MINUTES OF THE PRE-BID MEETING HELD ON 03.07.2017 AT 14:30 HRS FOR THE FOUR TENDERS VIZ.

Tender No. IWAI/MD/260/2017-18 :TENDER FOR DESIGN CONSTRUCTION SUPPLY OF ONE NO RO-RO VESSEL FOR NW-2

TENDER FOR DESIGN CONSTRUCTION SUPPLY OF ONE NO RO-RO VESSEL TO CARRY 12 TRUCK OF 25000 KG EACH WITH TWO RAMPS AND 200 PASSENGERS 100 SEATED

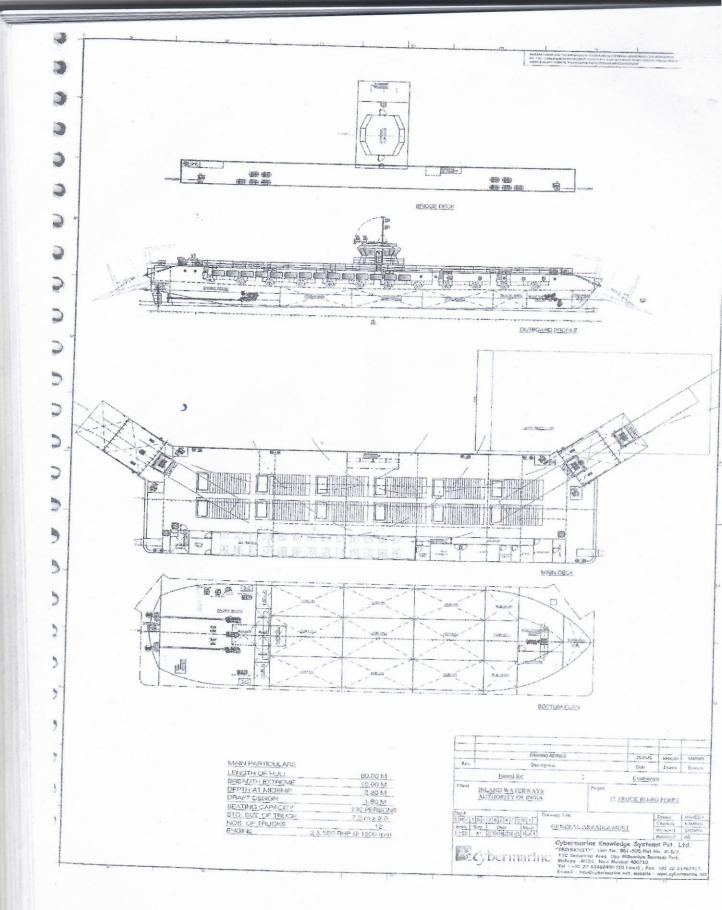
29	Technical Specification (Section-VIII) Clause 4.5.15	165	Piping and Valves: - Valves materials may be provided as per class requirements in lieu of cast steel as specified.	Agreed.
30	Technical Specification (Section-VIII) Clause 4.7.1	166	Capacities of pumps to be clearly given.  Pumps should be of any reputed make as per design capacity.	G.S/Bilge pump and fire pump shall be as per class requirement.  The pumps to be B.E. pump or any reputed make confirming to the class requirements.
31	Technical Specification (Section-VIII) Clause 5.2.2	169	Your specified capacity of Generator of 10 KVA may not meet the specified requirements. Hence the capacity may be changed to 65 KVA for main generator and 25 KVA for harbor generator.	The main DG of 65 KVA (minimum) to take entire load of the vessel with 30% margin. The Harbour Genset to be of 25 KVA instead of 10 KVA.
32	Technical Specification (Section-VIII) Annexure-1 GA	Page186 ,190 & 188	In the Spec it was mentioned GA is attached,	The GA is enclosed.

33	Technical Specification (Section-VIII) Clause 1.4 & Annexure-1 GA	129 & 186	Engine power has been given us the GA as 2x400HP for 9 Kts speed. Is speed VS power curve Available or it can be decided after model test.	2x400 HP is a minimum indicated power to be installed onboard. However if powering calculation and model testing results requires more engine horse power than same is to be installed for achieving 9 knots speed.
34	Liquidated Damages: Clause 56	85	We the yard owners on West Coast of India, cannot sail the vessel to Kolkata during 01 <sup>st</sup> May to 30 <sup>th</sup> November of the year due to East Coast define as foul Weather for the vessels registered under IV Act 1917. In such cases if the vessel is ready for voyage and delivery at Kolkata but cannot undertake voyage till December, the LD Clause should not be applicable. Yards on West Coast of India has to provide additional cost and period for voyage to Dhubri for delivery.	Not agreed. The condition of bid document shall prevail.
